Application Number: 10/030,818
Filing Date: June 07, 2002
Appellant(s): BRUDER, HANS

EXAMINER'S ANSWER

Claims 10-16 are rejected under 35 U.S.C. 102 (b) as being anticipated by Monti (U.S. Patent 4,410,157). This rejection is set forth in a prior Office Action, mailed on 3/24/2004.

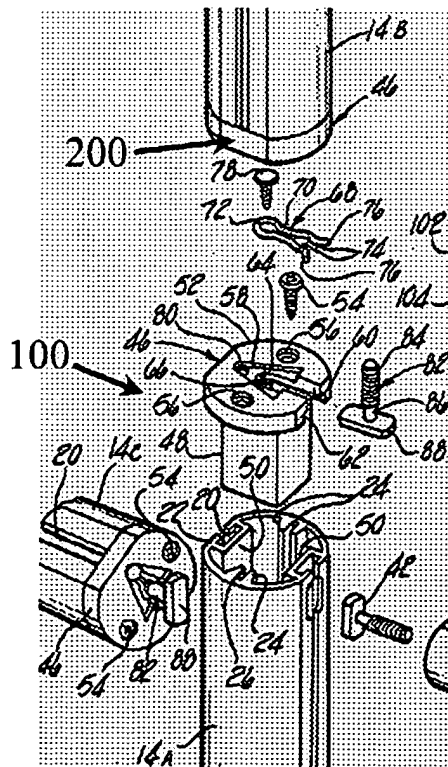
7. Monti discloses (figs.2 and 3) that hollow bodies (14A), (14B) and (14C) of (fig.3) are identical in structure to each other and to hollow bodies (14) of (fig.2), therefore the end piece (200 as seen in marked up figure 2) has a joint (28 as seen in fig.2) for connection (via 12) to another profile (14 of figure 2).

8. Monti discloses (fig.2) that the elements of the right most joint (right 28) are identical to the elements present in the left most joint (left 28) but are not labeled as completely on the left as on the right side. As such Monti discloses (marked-up fig.2) that the left joint (left 28) includes a first disk (left 32) which extends perpendicular to (in that 32 is angularly offset from 200 by 90 degrees) the end piece (200) and has a center bore (bore in 32 that receives 34), and a second disk (30) having a center bore (bore in 30 that receives 34) and being connected with the first disk (32) by means of a bolt (34) extending through the center bores and acting as an

9. Monti discloses (fig.2) a bolt (34) with two ends (the head end and tip end of 34) wherein each end is exposed to view outside of the disks (30, 32).
10. Summers teaches that the head end (col.2, l.22) as well as the threaded end (fig.2) of a bolt should each be covered up with a hemisphere (10), since these ends are both unsightly (col.1, ll.1-5 and ll.40-50).
11. Summers teaches (fig.2) that direct contact or accessibility is not necessary to “cover” an element. Note that the hemisphere (10 as seen in fig.2) covers the disc shape bottom element without contact simply by being over it.

marked-up figure 3
of Monti

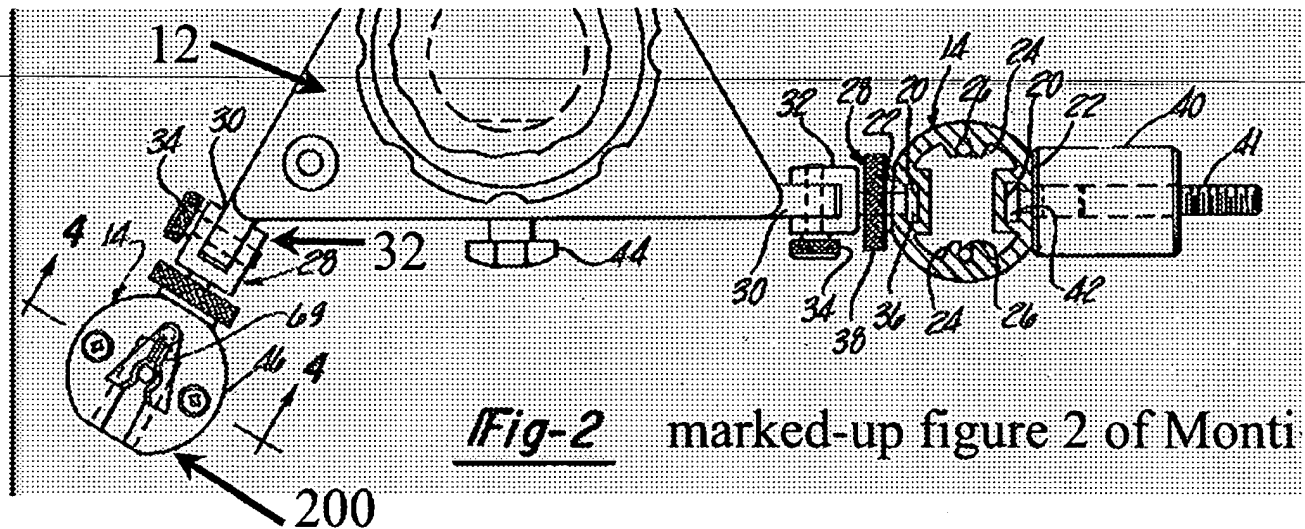
3. Monti discloses that the supporting profile (fig.3) further comprises: an adapter piece (46 received within top of 14A, designated as 100 by the examiner in marked-up fig.3 above) inserted into and secured to the first end (top of 14A) of the elongated body (14A), the adapter piece (100) having a receiving chamber (66).

4. Monti discloses (fig.3) that the receiving chamber (66) is provided with a hollow interior (hollow interior of 66) and as such is inherently capable of receiving therein portions of turnbuckles that are small enough to fit therein.

5. Monti discloses that the supporting profile (fig.3) further comprises: a disk-shaped end piece (52 as described by Monti in col.3-4, designated as 200 by the examiner in marked-up fig.3 above) disposed at the first end (top of 14A) and connected (via 82) to the adapter piece (100), wherein the disk-shaped end piece (200) is mounted (via 100) on a face (top face of 14A) of the hollow body (14A) and is fastened to the adapter piece by fasteners (68, 82, col.5, ll.20-26).

6. Monti discloses (fig.3) that the end piece (200) has a concave recess (curved portion of 64 in 200, not shown in fig.3 but necessarily there since upper and lower 46 are of identical construction) adapted (by 82 to be connected with 20) to an external curvature of a round profile (the round profile [i.e. outline] of 14 near 20)

The applicant argues that element (200) as shown in the marked-up drawings of Monti is not disk-shaped. The examiner disagrees. Applicants own disk-shaped end piece (5) is not a perfect disk in that it has elements 9 and 10 adjoined. Applicant further describes element 15 as a disk even though it is unitary with 16 to form the shape of a key as seen in fig.5. As such, element 200 of Monti is disk shaped in as much as the applicant's own invention is.

The applicant argues that the Monti receiving chamber (66) is not capable of receiving a turnbuckle. The examiner disagrees. Monti discloses (fig.3) that the receiving chamber (66) is provided with a hollow interior (hollow interior of 66) and as such is inherently capable of receiving therein portions of turnbuckles that are small enough to fit therein.
